**Sacramento Valley Live Steamers Irrigation Project
Cordova Recreation & Park District
Addendum #1 Issued on Wednesday April 18, 2018**

ADDENDUM #1
PLAN REVISION

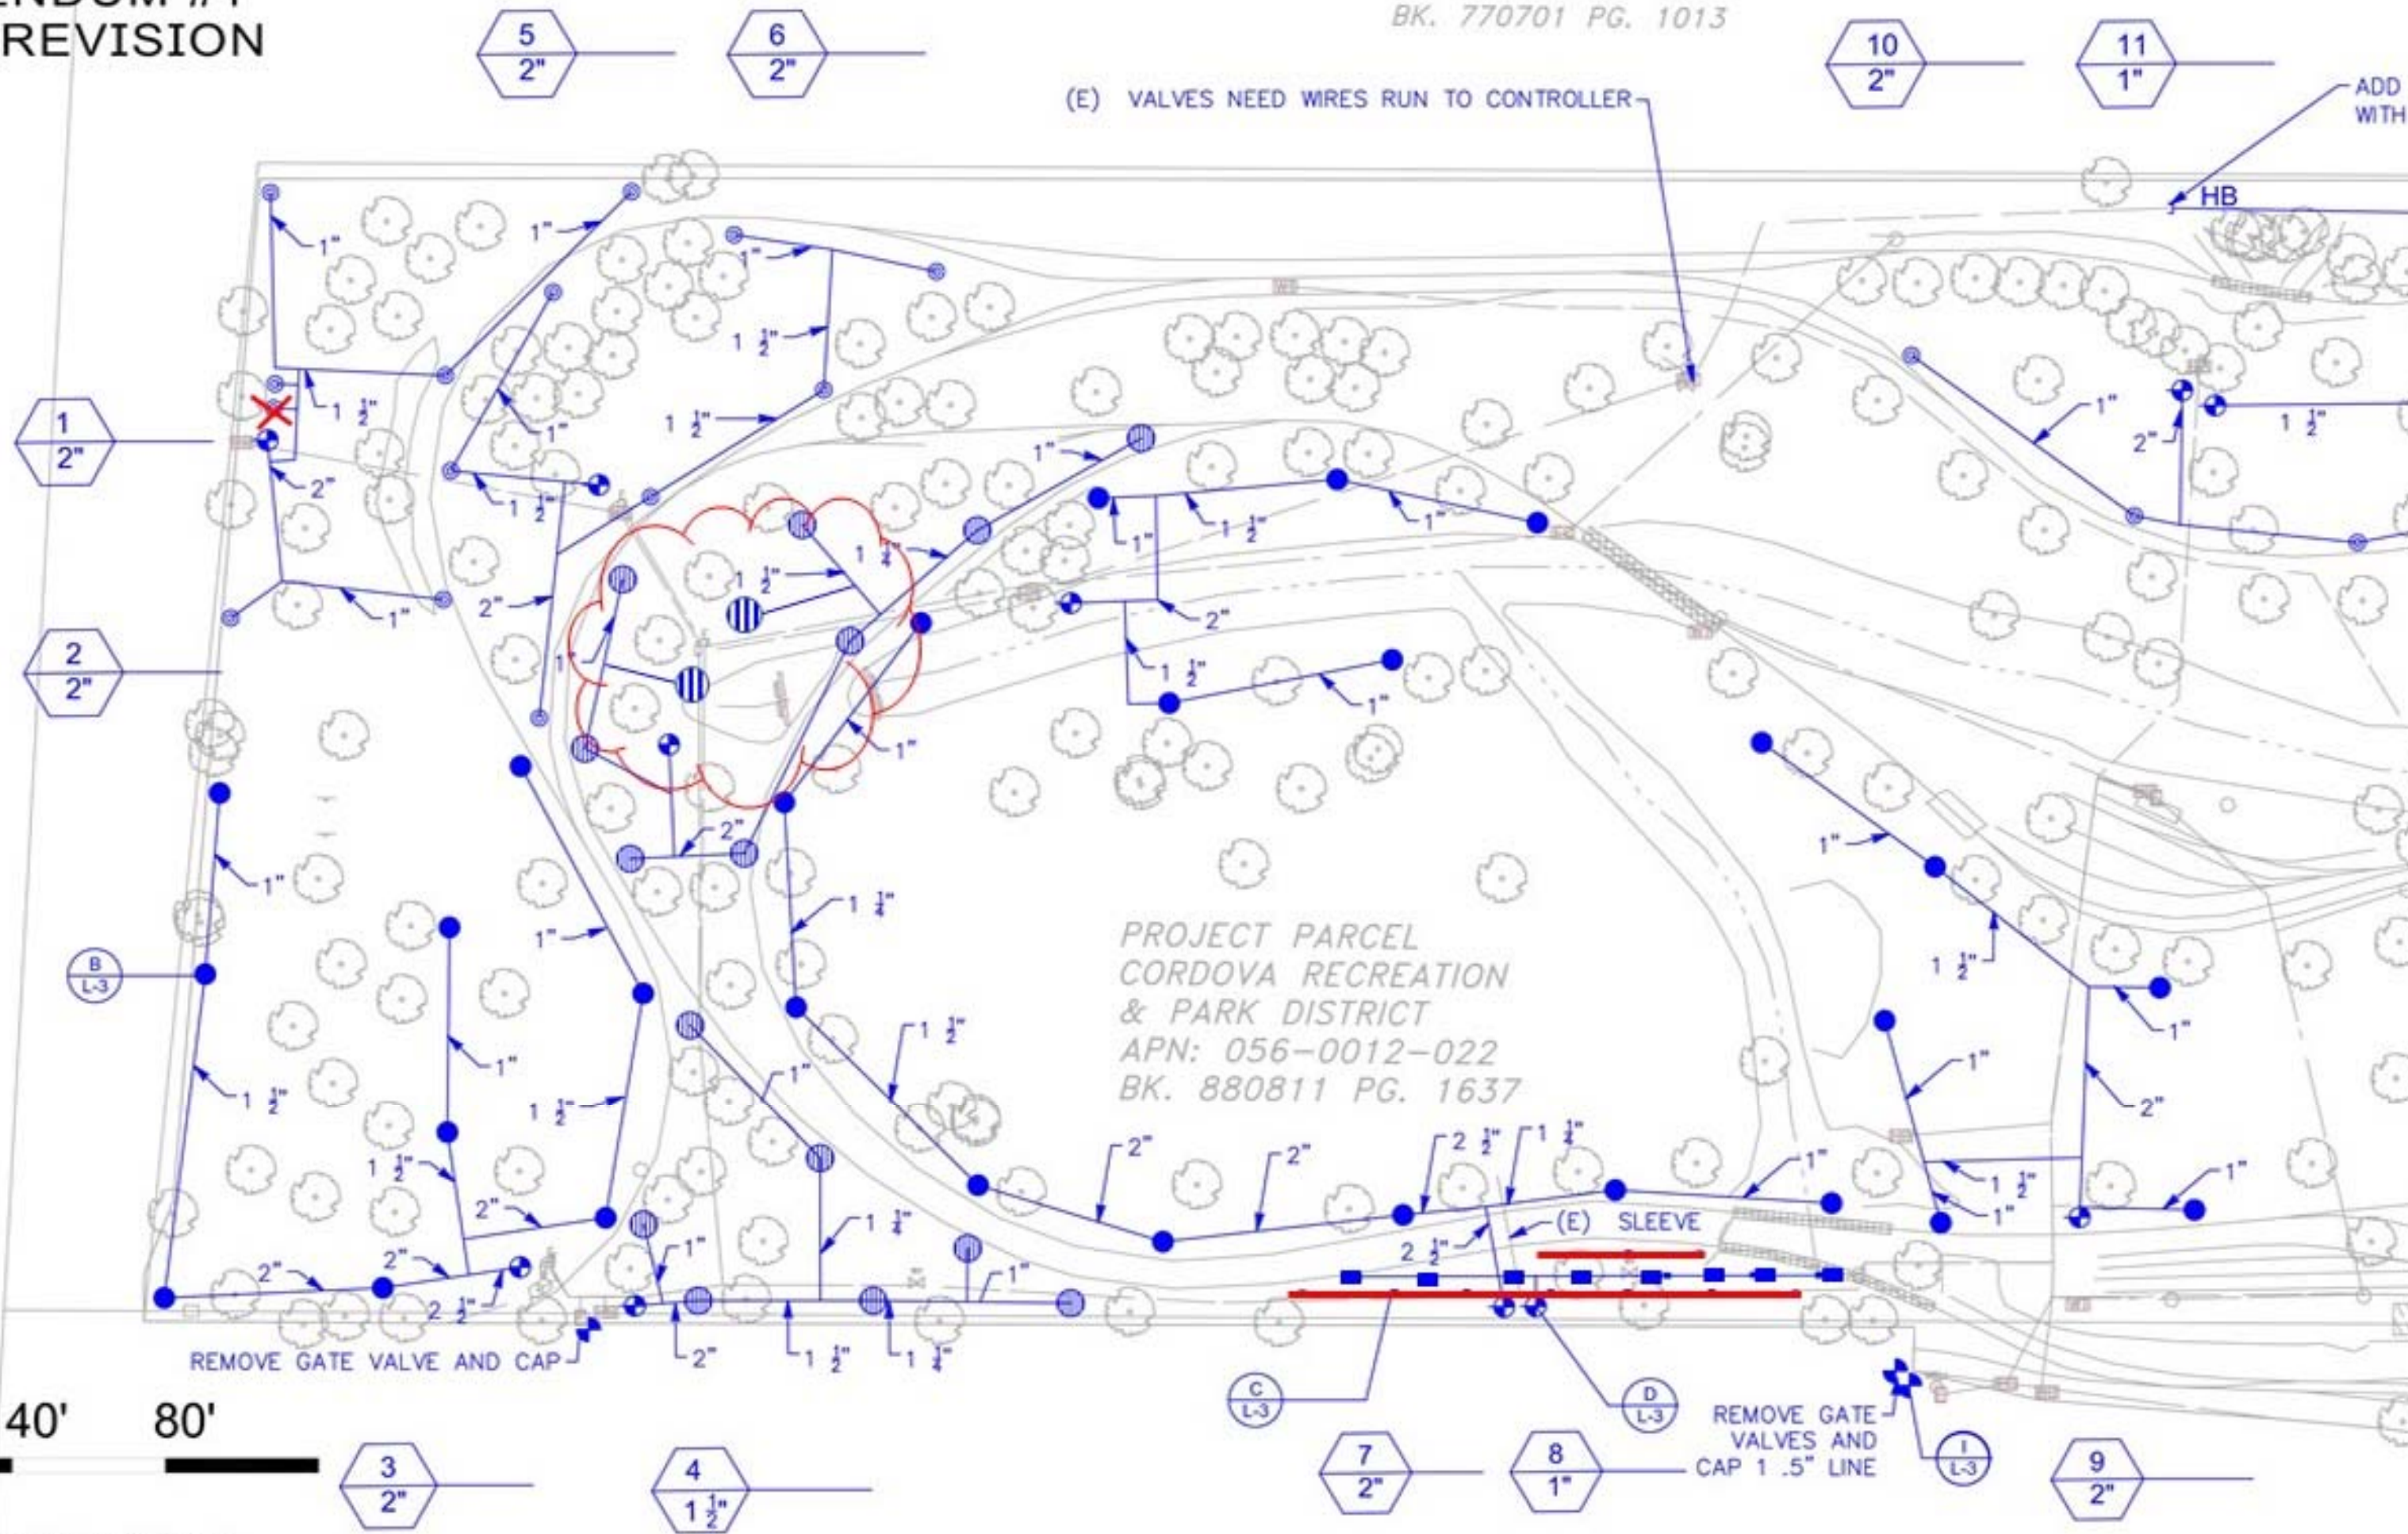
1. CHANGE: The '5500' heads should be '5006' heads.
2. CLARIFICATION: The Contractor shall not be responsible for any moving of the tracks. If tracks need to move, the Sacramento Valley Live Steamers will perform this.
3. CLARIFICATION: A clearer version of the additive alternate plan has been provided for bidder's use.
4. CHANGE: Revisions have been made to the base bid plan. Please see attached plan.

(E) VALVES NEED WIRES RUN TO CONTROLLER
